**BOONTON RESERVOIR DAM**

**NJ 00255**

**PHASE 1 INSPECTION REPORT  
NATIONAL DAM SAFETY PROGRAM**

PHASE I INSPECTION REPORT  
NATIONAL DAM SAFETY PROGRAM

FIGURE 2

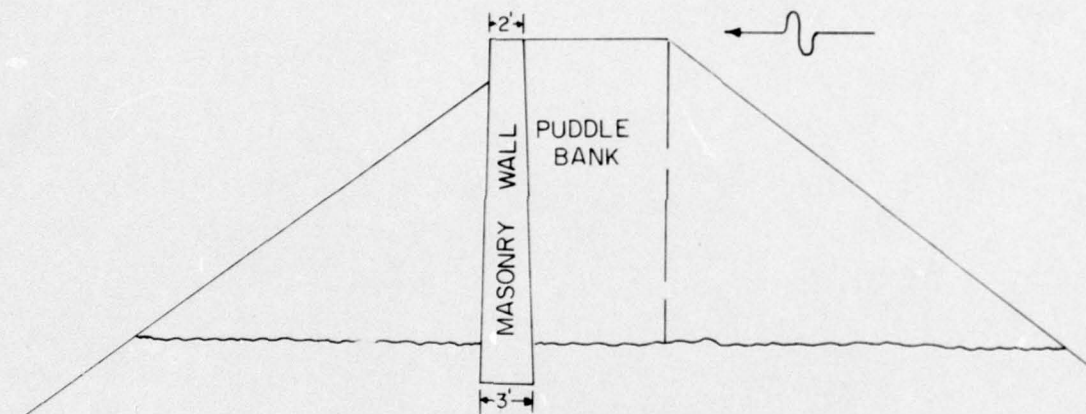
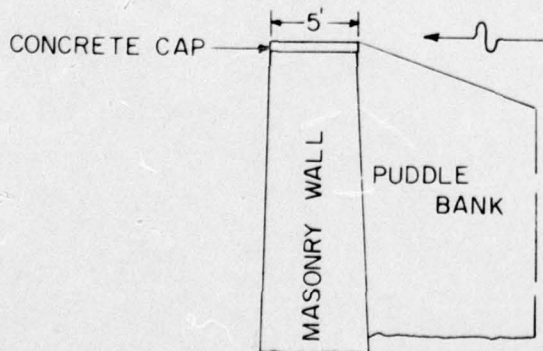
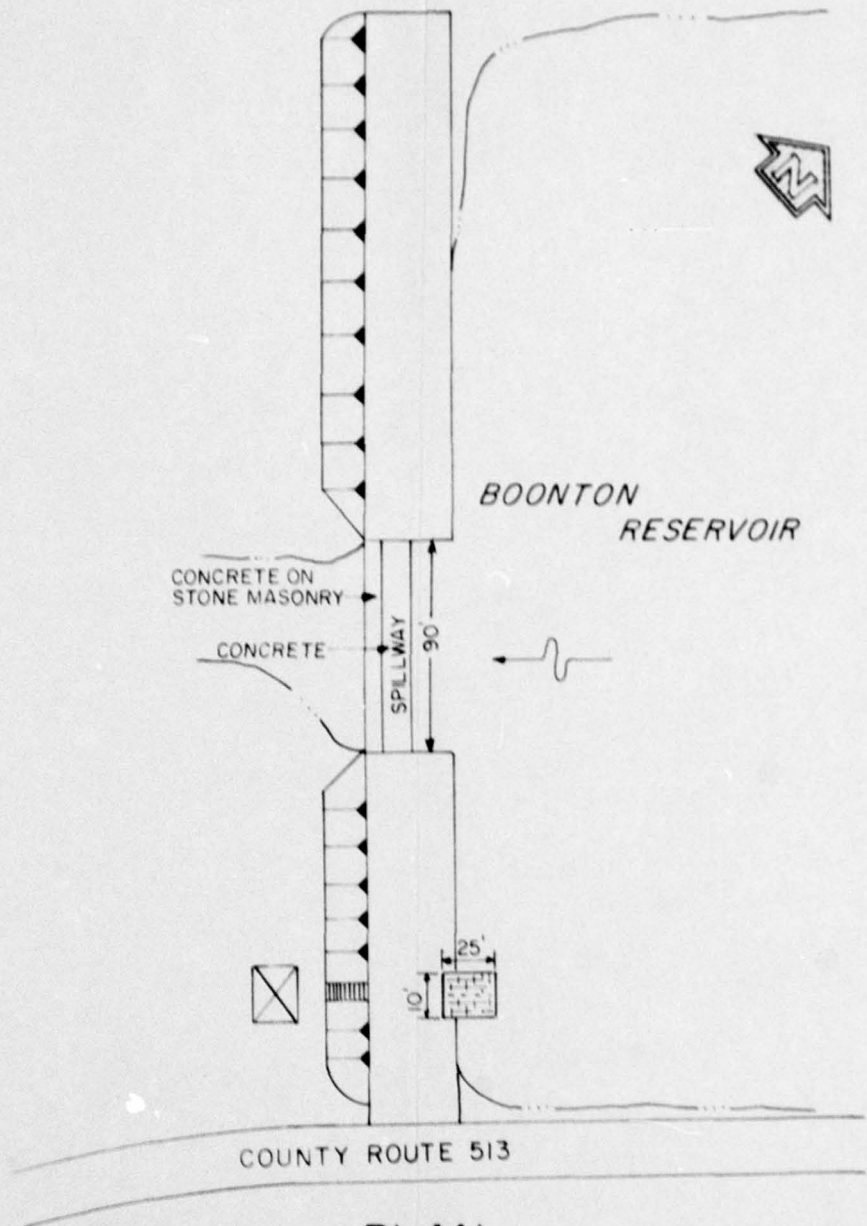
a. Dam. Trees and brush are growing on the crest, upstream face, and downstream face of the embankment between the spillway and the northwest abutment. Trees and brush are growing on the embankment from the southeast end of the spillway part way to the southeast abutment (ending about 2/3 of the distance from the left abutment to the spillway). Small brush is growing through the riprapped section of the downstream slope which extends from the southeast abutment part way to the spillway as shown on Figure 2. The riprap is in poor condition locally.

a. Design Data. Two hydraulic features of the structure did not agree with the original design plans. The spillway is shown to be 100 feet in length on the plans and is actually 90 feet in length. The low level outlet pipe, shown in the plans to exit through the face of the spillway, could not be found.

VIEW OF DOWNSTREAM FACE OF SPILLWAY

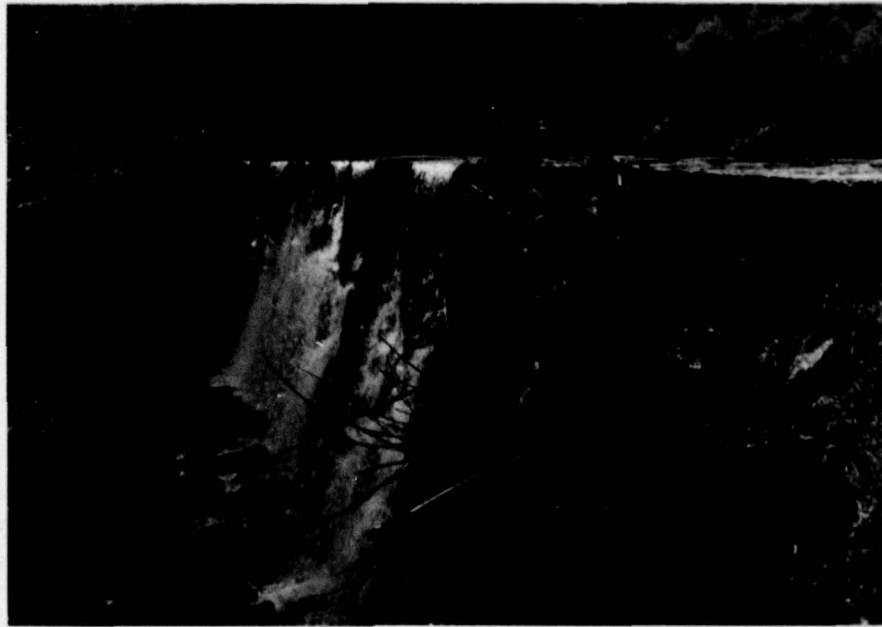
Tree stumps are located on the crest and downstream face of the stone masonry spillway. The concrete crest of the spillway is deteriorated and spalled. Several sections of the concrete crest have separated and brush is growing from the cracks.

The roots of tree stumps on the crest and downstream face of the masonry spillway may rot and leave open channels through spillway or the stumps may sprout new growth which will cause additional deterioration of the masonry and concrete. Continued deterioration of the concrete crest may result in erosion and loss of stone masonry under the concrete cap.

(4) Design and supervise procedures for removal of the stumps on the crest and downstream face of the masonry spillway, and repair the holes created.

(6) Design and implement remedial measures for repairing the concrete crest of the spillway.
